September 2020

Crows Nest Over Station Development Submissions Report

Sydney Metro City & Southwest

Figure 6.3: 21 September 4.00pm, overshadowing impact of Exhibited Scheme (pink) and Amended Scheme (black)

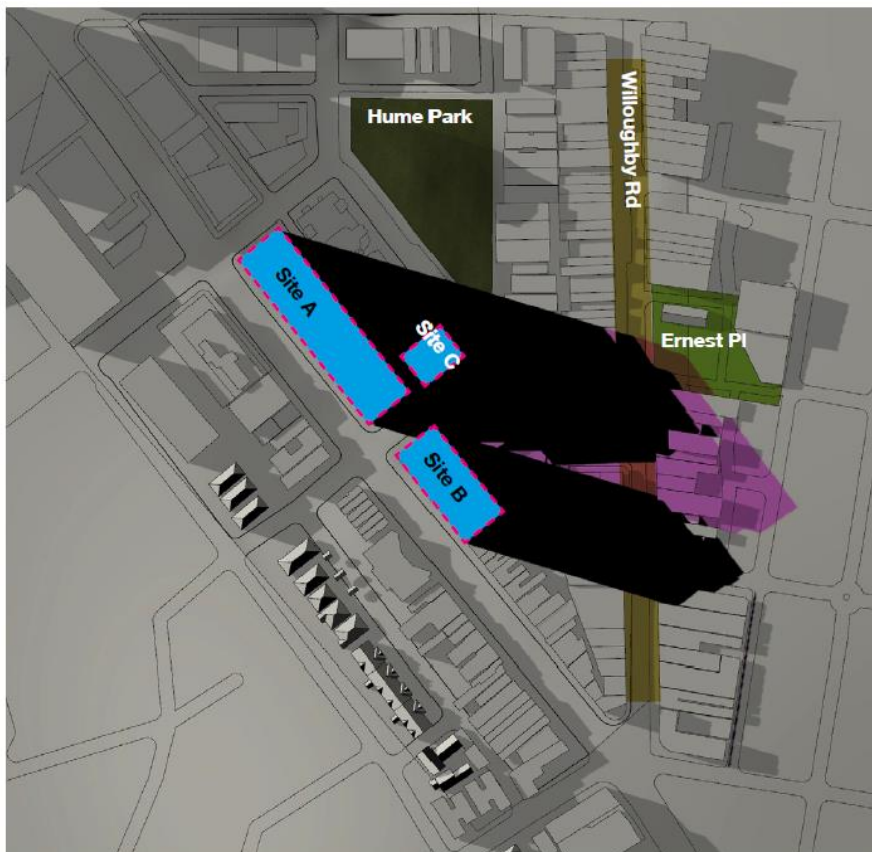
It is noted that some stakeholders are seeking no overshadowing of Ernest Place at all. Sydney Metro has undertaken design investigation to determine what would be required to achieve this outcome. In short, achieving no overshadowing at Ernest Place would require the top two levels of the building to be reduced by half (around 700sqm of lettable space) at the northern end.

The area of overshadowing impact at 4pm is located in the south-west corner of the site. The shadow only impacts on areas of transient activity (i.e. the footpath) and the shadow does not extend beyond the stairs (as shown in the photo below) or affect the green space areas of the park.

It is also noted that there are existing trees and awnings in this part of the site that may also provide shadows to Ernest Place.
